25-51SP Home Depot

Staff Report

Address:	204 Chillingham Ave
Request:	Construction of a retail home improvement store with outdoor garden center
Owner:	2001 Laurel LLC
Applicant:	Home Depot USA, Inc.
Agent:	Jackson R. Boone, Esq., Boone Law Firm
Parcel ID:	A portion of 0380-02-0001
Parcel Size:	11.29 ± acres
Future Land Use:	Mixed Use Corridor
Current Zoning:	Commercial general
Comprehensive Plan Neighborhood:	Laurel Road Neighborhood
Application Date:	August 6, 2025
Associated Petitions:	25-52CU and 25-53DA

Site and Development Plan

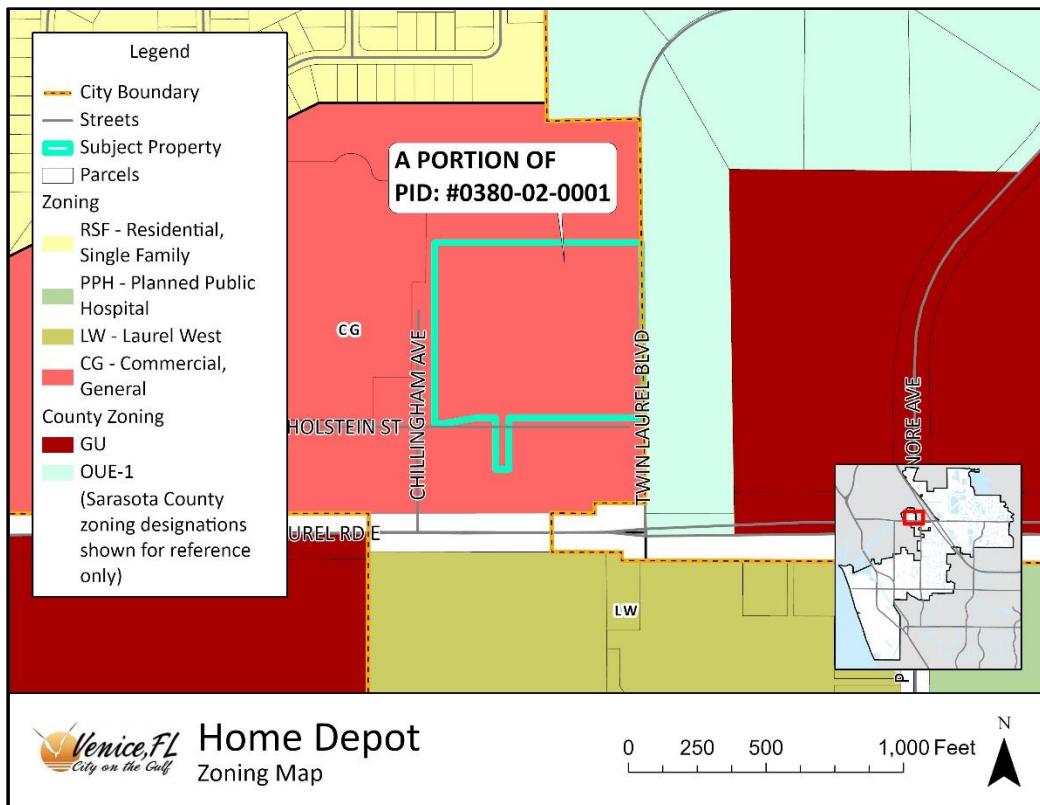
The Site and Development Plan proposes constructing a retail home improvement store with outdoor garden center. The proposed project has been reviewed for consistency with the LDC. The proposed plan, outside of the requested design alternatives and conditional use concurrently running, complies with the LDC and has been reviewed for compliance with regulations, including but not limited to, use, parking, setbacks, land area, height, lot coverage, lighting, and landscaping requirements.

Standard	Required/Allowed by CM Zoning	Provided
Front Setback	20'	316.4'
Side Setback East	20'	89.2'
Side Setback Interior	8'	84'
Rear Setback	10'	67'
Building Height	35'	34'
Parking (min-max)	3-6/1000 square feet 320 min/640 max	401
